GENERAL TELEPHONE & ELECTRONICS
FACTORY PREPARED
TECHNICAL SERVICE DATA

SUPPLEMENT 1 TO BULLETIN
S32-6

———— CODE CHANGES ————

Figure 1

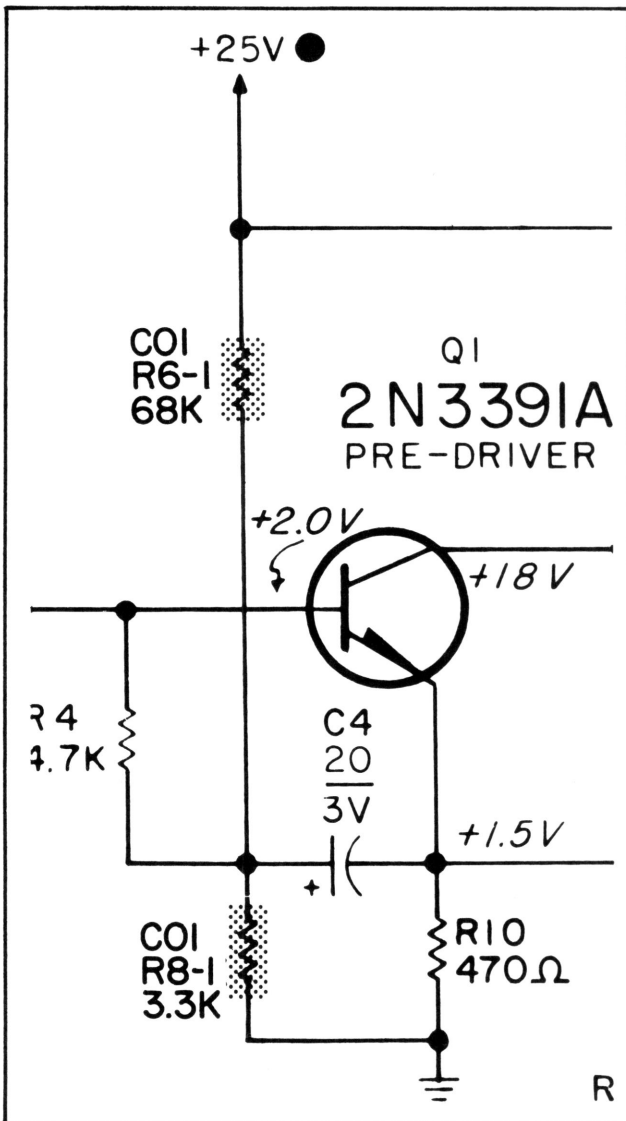
REASON: R72 and R74 overheating at high line voltage with high Beta driver transistors.

1. R6 (56K) changed to R6-1 (68K). See Fig. 1.
2. R8 (4.7K) changed to R8-1 (3.3K). See Fig. 1.
3. R40 (56K) changed to R40-1 (68K). See Fig. 2.
4. R42 (4.7K) changed to R42-1 (3.3K). See Fig. 2.

Figure 3

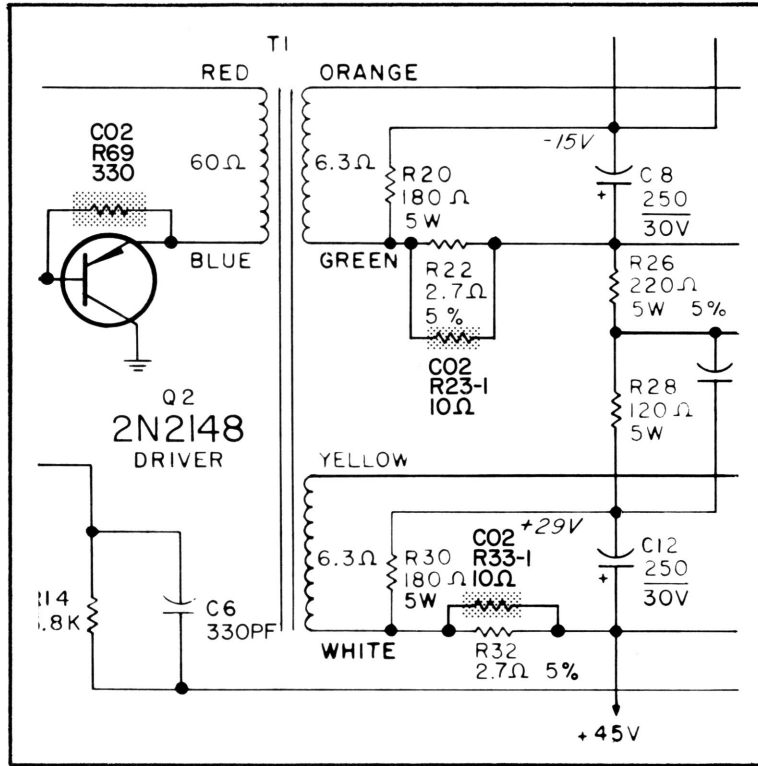
REASON: Q2 and Q8 biasing changed.

1. R23 (6.8 ohm) changed to R23-1 (10 ohm). See Fig. 3.
2. R33 (6.8 ohm) changed to R33-1 (10 ohm). See Fig. 3.
3. R57 (6.8 ohm) changed to R57-1 (10 ohm). See Fig. 4.
4. R67 (6.8 ohm) changed to R67-1 (10 ohm). See Fig. 4.
